## ADDENDUM NO. 3

Reference: Recreation Rehabilitation Phase 1 – Starvation State Park  
Division of Parks and Recreation – Duchesne County, Utah  
DFCM Project No. 08085510

Subject: **Addendum No. 3**

CENTRAL UTAH PROJECT  
BONNEVILLE UNIT - UTAH  
**STARVATION STATE PARK**  
RECREATION REHABILITATION - PHASE I  
FINISHED SITE PLAN

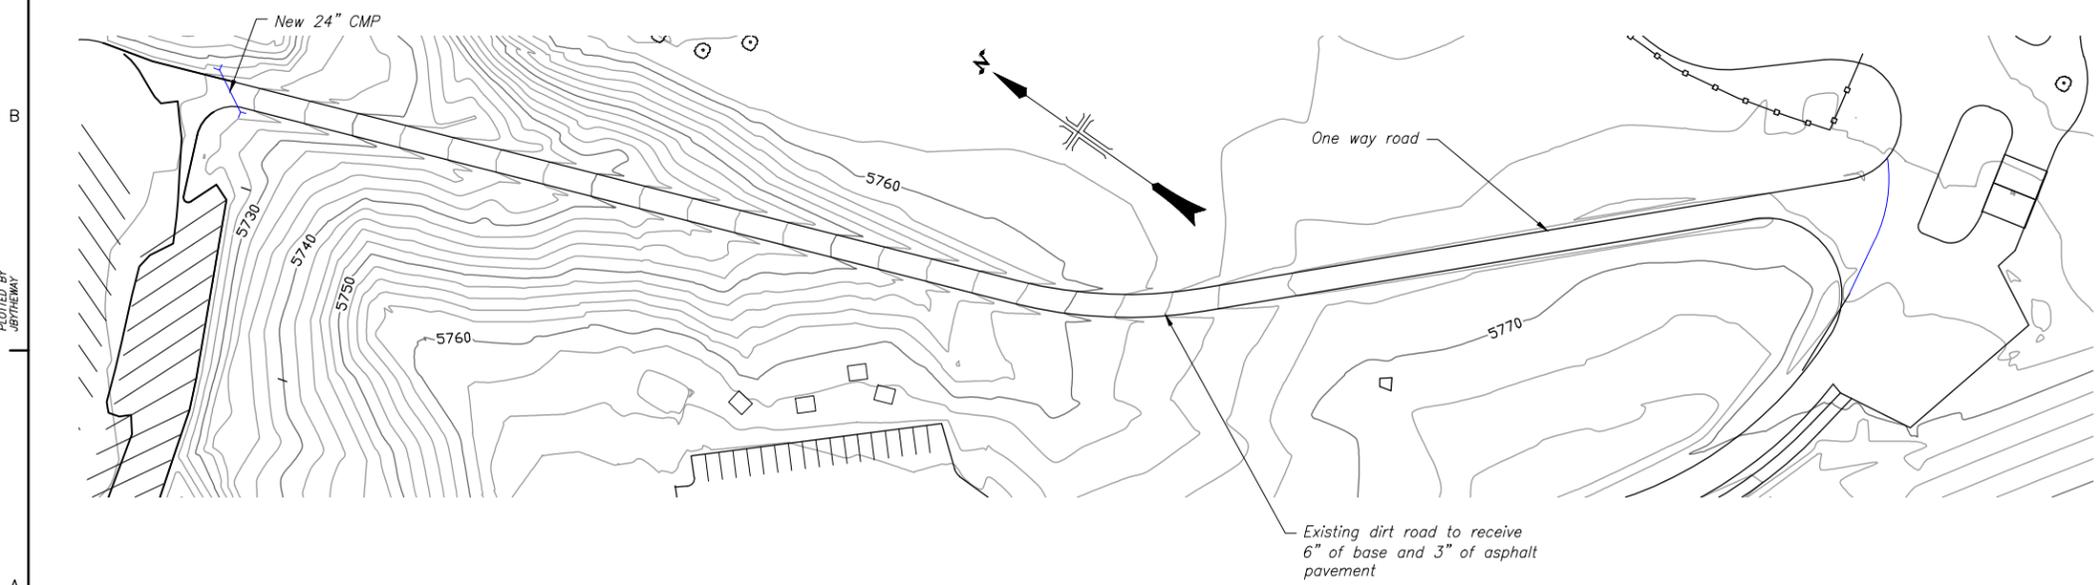
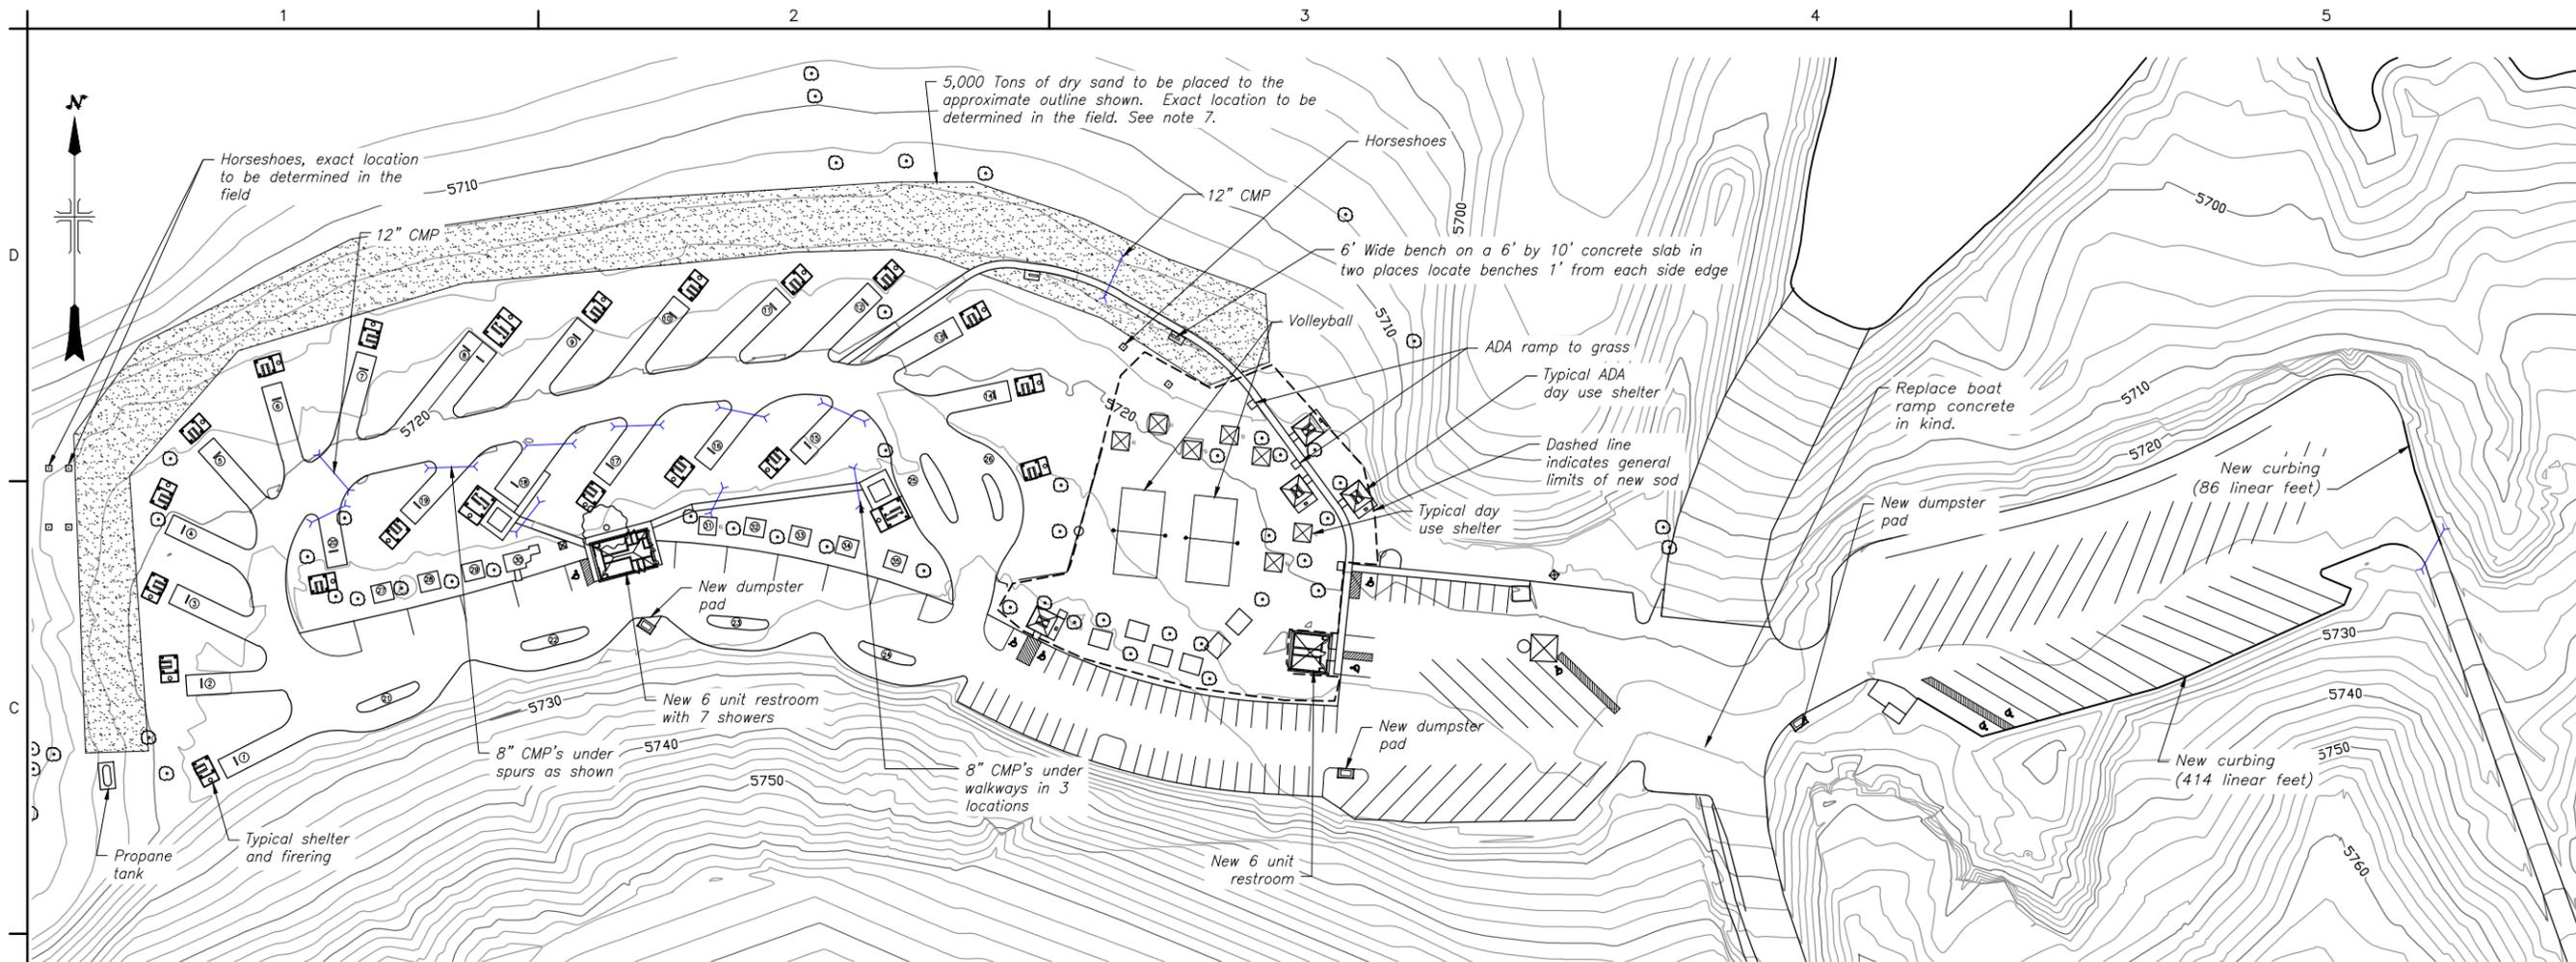
13. Please indicate extent of new sod and demolition of existing grass and irrigation system. There are no lines or dimensions showing where the grass or new irrigations stops and starts.  
*Answer - A dashed line has been added to Drawing 66-400-1732 indicating the approximate boundaries. Also a dashed line has been added showing existing grass*

14. Please indicate the extent of grubbing and tree removal required on the beach prior to sand placement. Plans indicate grubbing is to be included but existing conditions are greater than what is shown on the drawings.

*Changes to Drawing 66-400-1732 have been made to clarify.*

- NOTES**
- Day use area to receive new sod and new sprinkler system.
  - Leave erosion control materials in place after construction is finished.
  - Seed campground area with native seed.

- Place a day use concrete pad and grill at site 31, but no shelter and no shelter footings.
  - Earth quantities: 2460 cubic yards cut and 3430 cubic yards fill.

- Boat ramp concrete is approximately 7" thick with #6 rebar 12" on center each way in the center of the slab. Apply a rake finish similar to the existing finish and duplicate construction joints. Add material to existing road base as needed and roll material to compact prior to placing the new slab.

- Grubbing and grading is required prior to placement of sand. Remove vegetation to perimeter edge of sand placement; however, do not remove trees. Sand will be approximately 2 feet deep.

- Move the Propane tank to the location shown and construct a new concrete pad and fence to duplicate the previous pad and fence. Contractor will determine the location of the new propane gas line.

Changed Note 6, Added Note 7. Added concrete curb. Added and perimeter. Moved propane tank and added Note 8.  
2010-06-21  
400  
1  
JBYTHEWAY

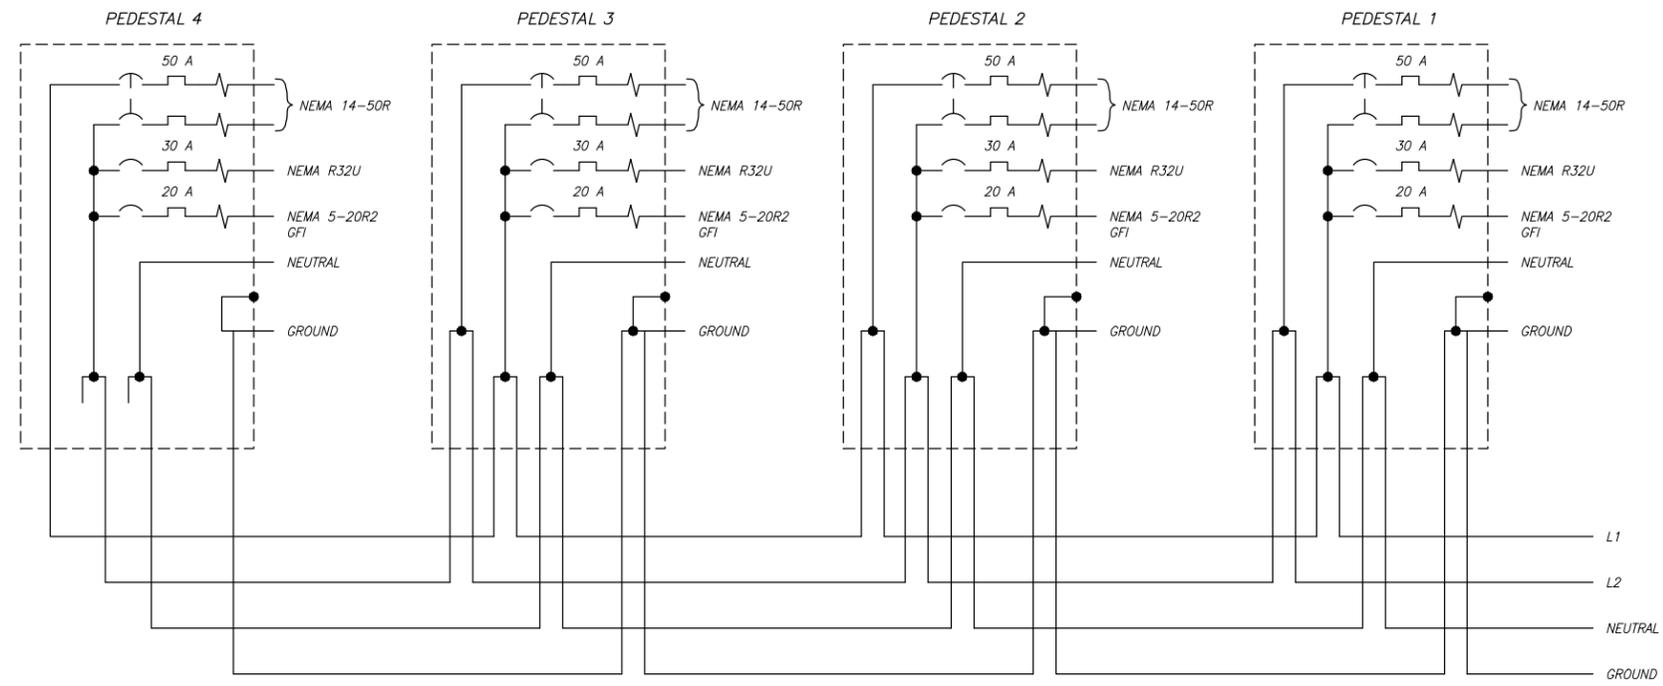
15. I am bidding the utilities for the Starvation State Park project and had a question and comment. You have down that you would like curb stops on the 4" line. As far as I am aware of the biggest curb stop is 2", would it be ok to bid a Mueller A-2360 gate valve instead? I have attached a submittal for this.

*Answer - The terminology will be changed to shut-off valve which is understood to mean any manufactured water valve which can shut off the water supply and isolate any line in the system.*

2010-06-22  
 400  
 1  
 Jay Bytheway  
 Changed symbol description from curb valve to shut-off valve. Added note 6.

TYPICAL PEDESTAL INTERCONNECTION  
SEE NOTE 1

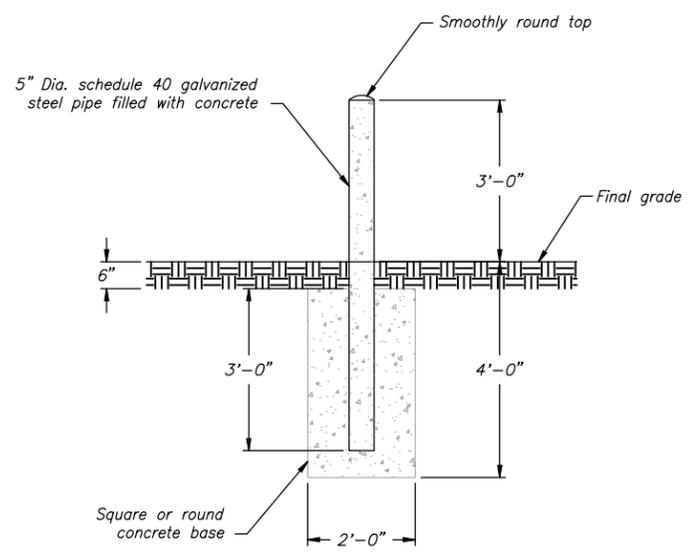
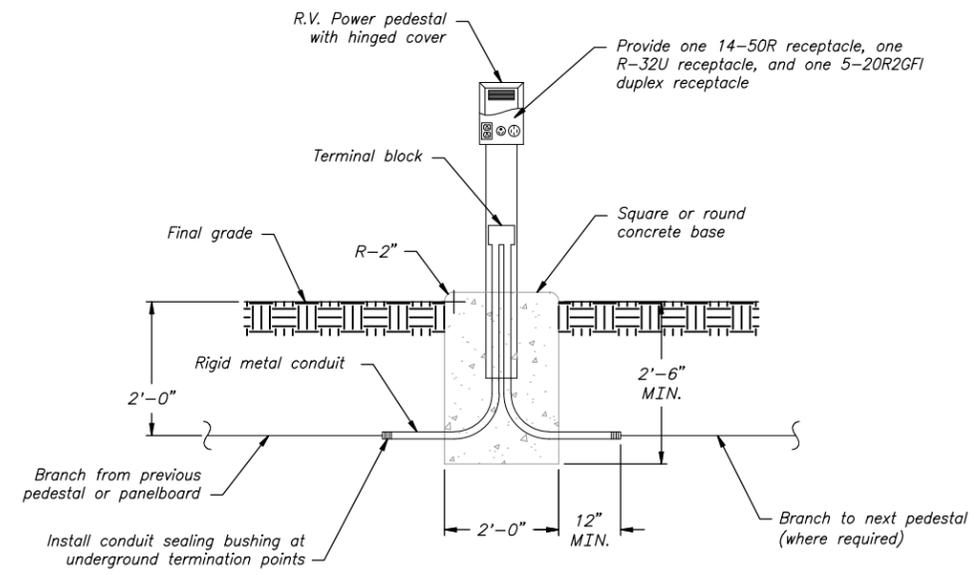
15. How do want the terminate the carry through electrical phase as noted on sheet 1747 note 1?  
*Answer - The circuit has been redrawn.*
16. 6 unit flush RR - There are no electrical panel details or location, also is there a meter/disconnect similar to Panelboard LP, if so what size?  
*Answer - See the answers to questions 6 and 8.*

18. Power Pedestals - How should the circuits alternate regarding the 2-pole 50 Amp 240 Volt receptacle 14-50R? Does this need to be re-drawn?

*Answer - The circuit has been redrawn.*

Revised Typical Pedestal Interconnection Diagram  
REV. NO. 1  
2010-05-22  
JAY BYTHEWAY

**FLOOR PLAN**  
SCALE OF FEET

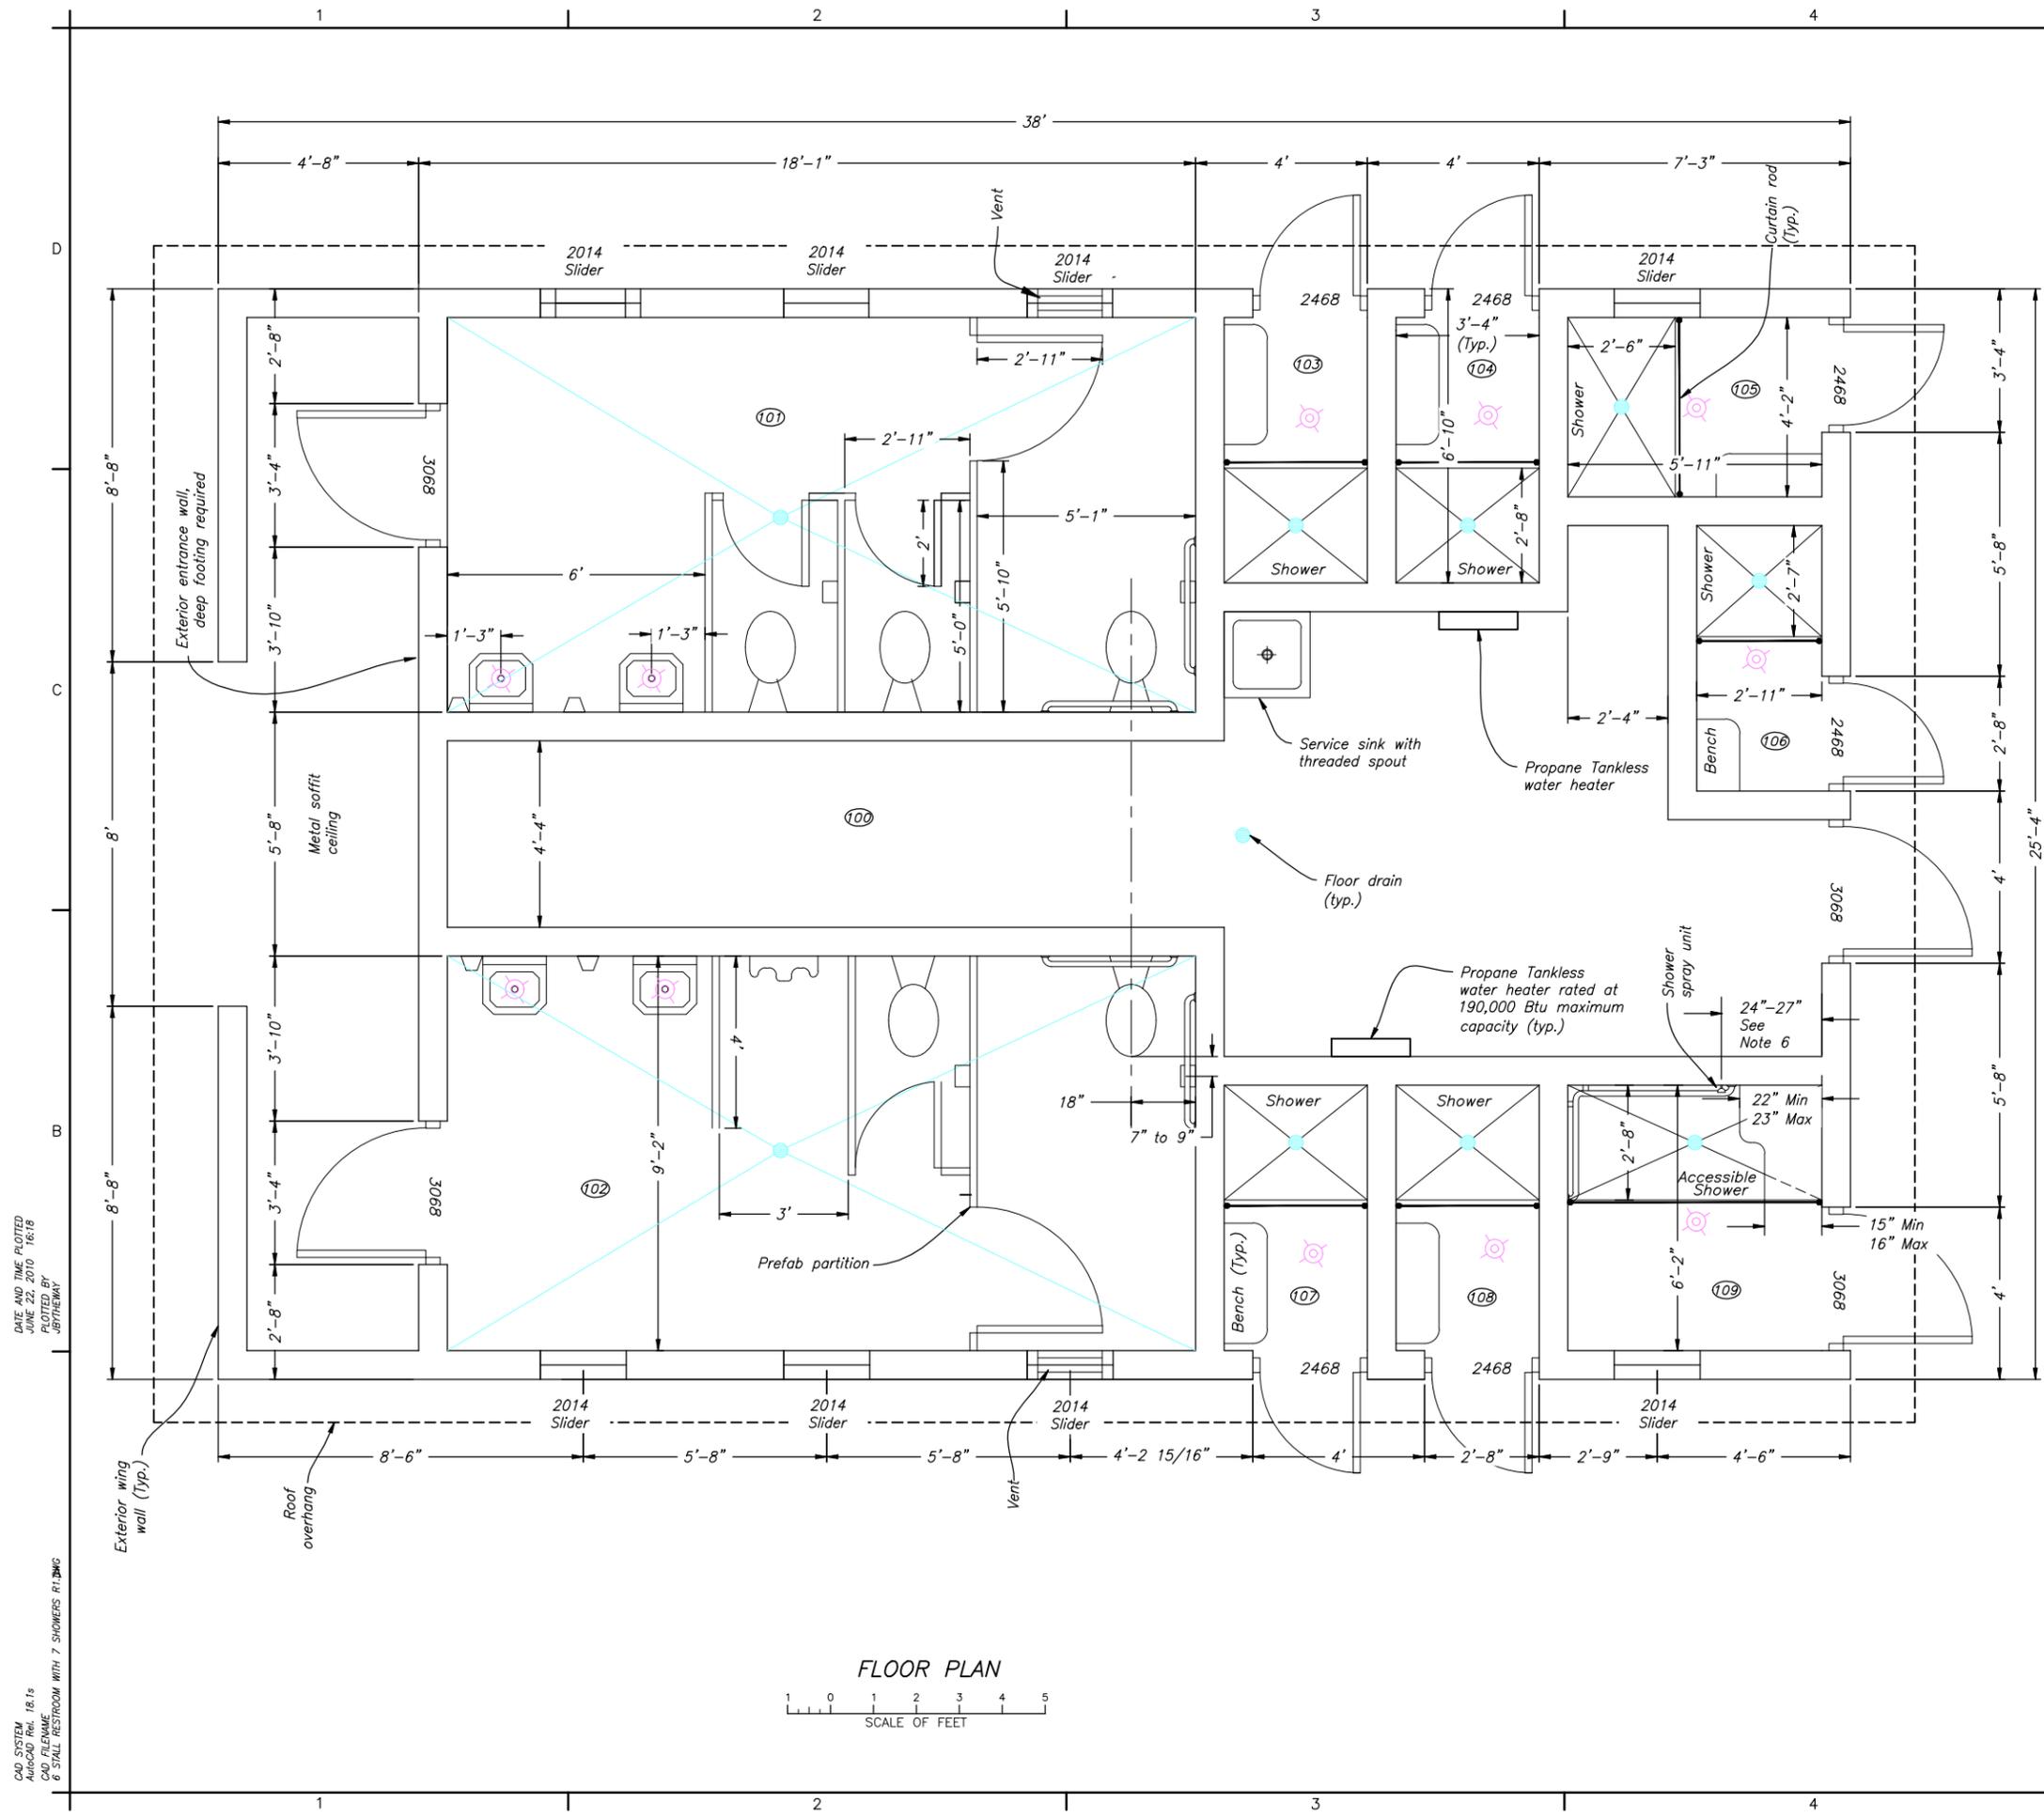
1. Please confirm ceiling finish for C2 is fire taped type x drywall with no paint.

4. Please confirm the showers stalls have two (2) ea floor drains. (one in the shower and one in the "drying" area.)

5. Please confirm the Main bathroom areas (around the sinks) have one (1) ea floor drain.

6. Please confirm the storage area between the bathrooms has one floor drain.

*Answer - A C2 finish description will be added to drawings.*

*Answer - Only one drain is shown on the plans. The other symbol is a solatube type skylight which could have been mistaken for drain.*

*Answer - Drawings will be modified to clarify location of floor drains (near the center of the room). Each sink has a solatube type skylight over it.*

*Answer - Drawings will be modified to clarify location of floor drain. One floor drain has been added to each storage area.*

Added CS ceiling finish description.  
Changed drain symbol & added drain in storage room.  
Changed water heaters from electric to propane.  
REV NO 1  
DATE 2010-06-22  
BY JBY
